We're good to go on the changes for the Final Issue of the HPNS D-1 RACR. Gilbane provided a good explanation in the forwarded e-mail chain, but we're planning to submit "clean" copies of the Final to avoid the change-page confusion. I think I will need to process a lean contract modification for the additional deliverable, but Gilbane was seeing if they could support it through unused meeting funding.

Subject: [Non-DoD Source] Final Issue of HPNS D-1 RACR, Ship Berths FSSR, and NRDL FSSR

Response to Document Review Comments			
Document Reviewed:	DRAFT Removal Action Completion Report Parcel D-1 Phase II Radiological Remediation and Support , Hunters Point Naval Shipyard, San Francisco, California.	Date of Document:	DRAFT August 2017 DRAFT FINAL Jan 2017
Project Site:	Parcel D-1, Hunters Point Naval Shipyard, San Francisco, California

Exhibit 8-8. Locations where Discrete Radioactive Objects were Recovered

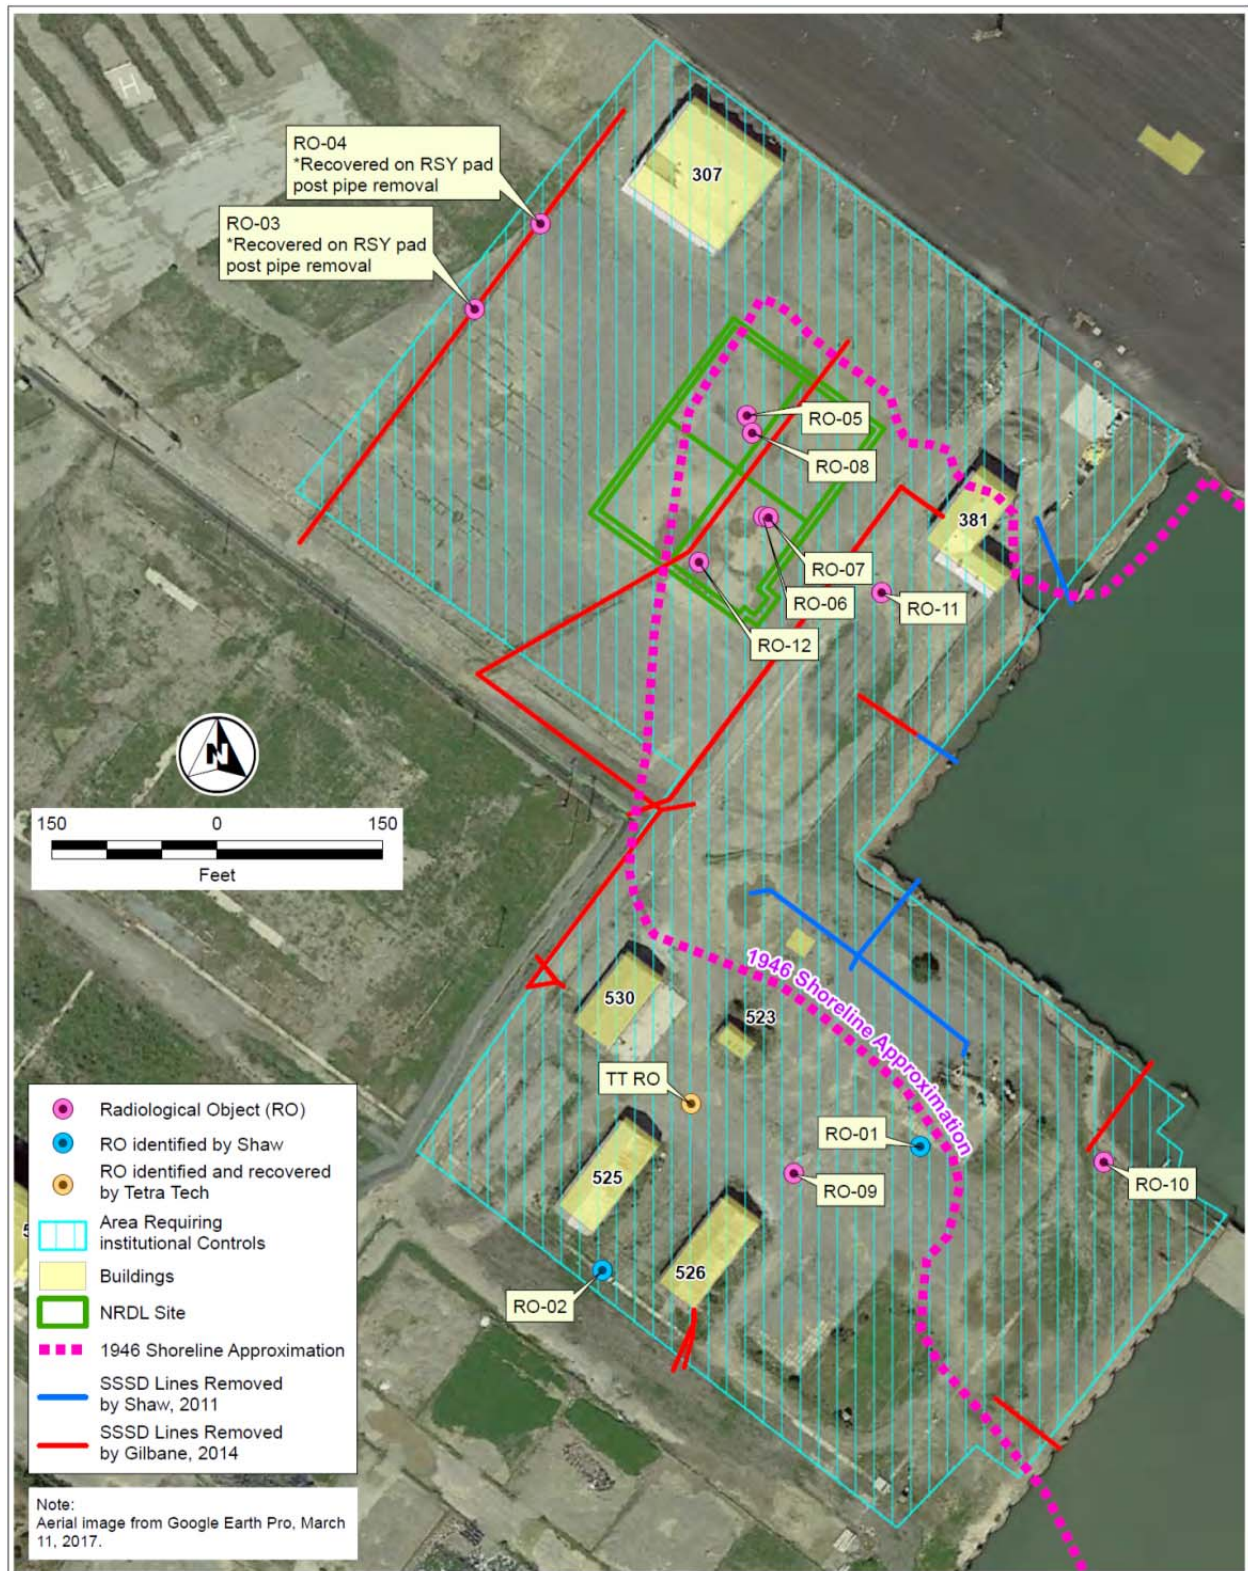
30	<p>(SFDPH Specific Comment #14)</p> <p>Exhibit 8-8, Locations where Discrete Radioactive Objects were Recovered, page 52 and Section 8.3, Assessment of Results, page 53:</p> <p>The last paragraph states "...there is the potential for ROs to be present in material below 2 ft bgs in Parcel D-1 Phase II areas where shoreline expansion occurred in Parcel D-1 since 1946 (i.e., where dredge material from the Bay was used to create the present shoreline)." Please clearly identify this area on Exhibit 8-8 and label as "Area with Potential for Buried ROs." Was dredge material used elsewhere in Parcel D-1/other parcels inland of the 1946 shoreline? We note that Exhibit 8-8 shows ROs inland of the historic shoreline. Exhibit 8-8 needs to be revised or a new figure needs to be created to address the concerns in Comment #1.</p>	<p>Dredge spoils were used to expand the land present in 1946 to its current state in Parcel D-1. The ROs found inside of the 1946 shoreline are consistent with the conceptual site model of dredge spoils. Section 8.3 was modified to better explain and provide definition to the Navy's understanding regarding the area impacted by dredge material used to expand the land to its current state as follows: <i>"Based on the Navy's understanding of how shoreline expansion occurred, that potential [for ROs to be present in material below 2-ft bgs in Parcel D-1 Phase II</i></p>

36	(SFDPH Comment #5 – Section 8.3 Assessment of Results, Exhibit 8-8, Page 55) Please label the fuchsia dotted line as the 1946 shoreline.	Exhibit 8-8 was modified to label the fuchsia dotted line as the 1946 shoreline approximation.
37	(SFDPH Comment #6 – Section 13.3, Discrete Radioactive Objects, page 67) Section 13.3 states "Implementation of land use and activity restrictions as prescribed by the ROD (Navy, 2009) and further detailed by the Land Use Controls Remedial Design in the Final Design Basis Report For Parcel D-1, Hunters Point Naval Shipyard, San Francisco, California (ChaduxTt, 2011), which prohibit land-disturbing activities throughout Parcel D-1, will appropriately mitigate any risk to human health relating to the potential presence of ROs in material below 2 ft bgs." Please see comment 1 and please either delete this statement or modify this statement to reference a subsequent document that will define required activity restrictions based on the possibility of buried ROs below two feet.	Section 13.3, last paragraph, was modified to state, "Land use and activity restrictions that are currently in place prohibit land-disturbing activities throughout Parcel D-1 in the interim until the LUC RD (ChaduxTt, 2011) is amended to appropriately mitigate any risk to human health relating to the potential presence of ROs in material below 2 ft bgs."

42	(CDPH Specific Comment #2) – Exhibit 8-8: It is not clear to the reader if the blue hatched area marked as, "Restriction related to radioisotopes", on Exhibit 8-8, "Locations where Discrete Radioactive Objects were Removed"; is	The legend in Exhibit 8-8 was modified to call the cross-hatching the <i>'Area Requiring Institutional Controls.'</i> A sentence was included in the new

the same area(s) as the, "buffer zone", referred to in page 57, paragraph one, sentence five. Please clarify.	Section 8.3.2 that states, <i>"Therefore, a buffer zone extending beyond the 1946 shoreline approximation is included with the 2 ft bgs restriction for Parcel D-1 Phase II, which is referred to as the area requiring institutional controls (see Exhibit 8-8)."</i>
43	<p>(CDPH Specific Comment #3) – in reference to Navy response to Item #4: Navy Response, Review Comment, Item number four, sentence number four: "A couple of ROs recovered outside of the 1946 shoreline expansion area within the trench excavation zones are incidental and the likelihood of ROs outside that area is considered incidental and of low probability."</p> <p>a. Please note that the sentence number three states, "...as potential for RO is limited only within the 1946 shoreline." Please resolve apparent contradiction.</p> <p>b. Of particular concern are RO-03 and RO-04; which according to Exhibit 8-7, "Recovered Radioactive Objects Data", page 54, are deck markers recovered from Trenches #04-PD-015, Zone O, and #04-PD-016, Zone P, respectively. These ROs are solid deck markers; and therefore cannot be considered effusions from the SSSD line which was removed. Please present a Conceptual Site Model (CSM) which explains the presence of solid deck markers ROs outside the Historical 1946 Shoreline.</p> <p>c. A review of, "Exhibit 8-8, "Locations where Discrete Radioactive Objects were Removed", shows that seven Radiological Objects (ROs) were located inside of the "Historical 1946 Shoreline", while six ROs were located</p>	<p>Sentences were modified to read, <i>"...the potential is largely limited to areas around the 1946 shoreline (Exhibit 8-8). The likelihood of ROs moving away from the 1946 shoreline is considered incidental and of low probability."</i></p> <p>A new Section 8.3.2, entitled, 'Conceptual Site Model,' was added to explain the presence of ROs outside the historical 1946 shoreline approximation.</p> <p>A new Section 8.3.2, entitled, 'Conceptual Site Model,' was added to explain the presence of ROs both inside and outside the historical 1946</p>

Item	Review Comment	Navy Response
		<i>areas] is largely limited to areas east of the 1946 shoreline. The likelihood of ROs outside that area is considered incidental and of low probability “. Exhibit 8-8 was revised accordingly. Information. Information on land use controls will be presented separate from the RACR.</i>
31	(SFDPH Specific Comment #15) Section 13.2, Dose and Risk Modeling, Page 63, last paragraph: See Comment #1. It is not clear how the existing restricted activity framework will address the concepts described in this paragraph.	Information on land use controls will be presented separate from the RACR.

Exhibit 8-9. Illustration of Backfilled Near-Shore Areas

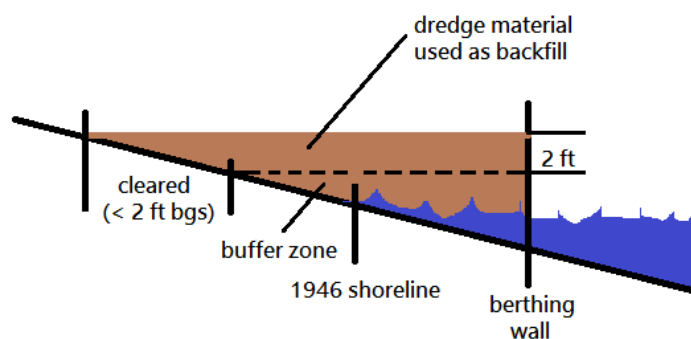
Exhibit 8-9 illustrates the purpose of a buffer zone. Though discrete ROs may have been identified and recovered to a depth of 2 ft bgs, areas backfilled with dredge material to depths greater than 2 ft bgs may extend further inland from the 1946 shoreline. The actual extent is a function of the original near-shore elevation gradient and the post-backfill final grade. That information is not available; therefore, an appropriately conservative buffer zone – encompassing discrete ROs found to date - should be established.
